RESS mechanical integrity

Annex 8D

Mechanical integrity

Figure 7:

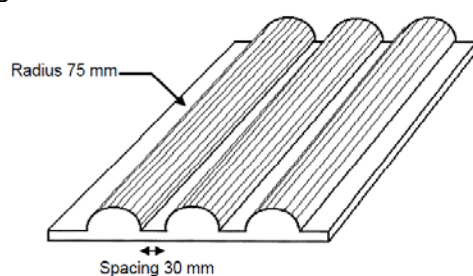
It is really important to specify a rise time and a hold time to have repeatable tests. Moreover, we think that the target effort value specified in the doc ress 100-2 (100kN) is too important (equivalent to the worst case of an underrun bar which is a safety component). Also, 100 ms is not a relevant hold time for a static test.

Crush a [RESS or pack(s)] between a resistance and a crush plate described in figure 7 with a force of 20kN with a rise time less than 3 minutes and a hold time of 30 seconds [100 kN] [X seconds; how fast] during [Y seconds; how long] at least 100 ms should be limited to a duration of [100] ms in direction of travel and horizontally perpendicular to the direction of travel of the [RESS].

We propose in blue:
